Access Compliance Report

Public Rights-of-Way

(Curb Ramps)

Intersection ID: 4036	Main Street: SHADY_REACH_LN	Cross Street: STONY_PATH_DR	Location: W
ADA ID: B6ED9A6CACCA	Ramp Type: Perp	Initial Pass/Fail: Fail	Overall Compliance: No
Severity Score: 10			
Codes/Mitigation Info/Possible Solution		Field Measurements/Component Compliance

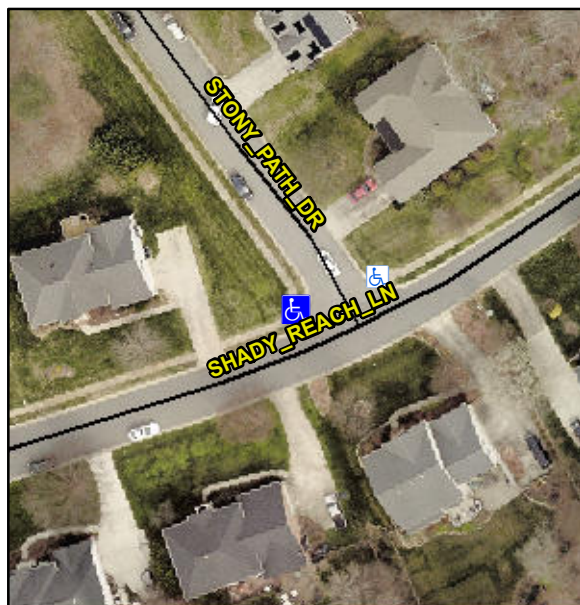
Not Found, R304.5.1, R304.5.3

Compliance	Description	Data	Compliance	Description	Data
N/A	Ramp Length (in)	48.0	Yes	Ramp Slope (%)	7.3
No	Ramp Width (in)	38.0	No	Ramp XSlope (%)	5.0
N/A	Flare Type LT	N/A	N/A	Flare Type RT	N/A
N/A	Flare Slope LT (%)	N/A	N/A	Flare Slope RT (%)	N/A
N/A	Flare Traversable LT?	N/A	N/A	Flare Traversable RT?	N/A
N/A	Landing Length (in)	N/A	N/A	DWS Provided?	N/A
N/A	Landing Width (in)	N/A	N/A	DWS Contrast?	N/A
N/A	Landing Slope (%)	N/A	N/A	DWS Length (in)	N/A
N/A	Landing X Slope (%)	N/A	N/A	DWS Full Width?	N/A
N/A	Landing Curb? (Y/N)	N/A	N/A	DWS Offset (in)	N/A
N/A	Shared Landing?	N/A			
N/A	Gutter Ponding?	N/A	N/A	Gutter Slope (%)	N/A
N/A	Gutter Lip Ht (in)	N/A	N/A	Gutter X Slope (%)	N/A
N/A	Painted X Walk1?	No	N/A	Painted X Walk2?	N/A
	X Walk 1 Direction	To E		X Walk 2 Direction	N/A
N/A	X Walk 1 Width (in)	N/A	N/A	X Walk 2 Width (in)	N/A
	X Walk 1 Slope (%)	2.9		X Walk 2 Slope (%)	N/A
	X Walk 1 X Slope (%)	1.5		X Walk 2 X Slope (%)	N/A

Remove & Replace Entire Ramp.
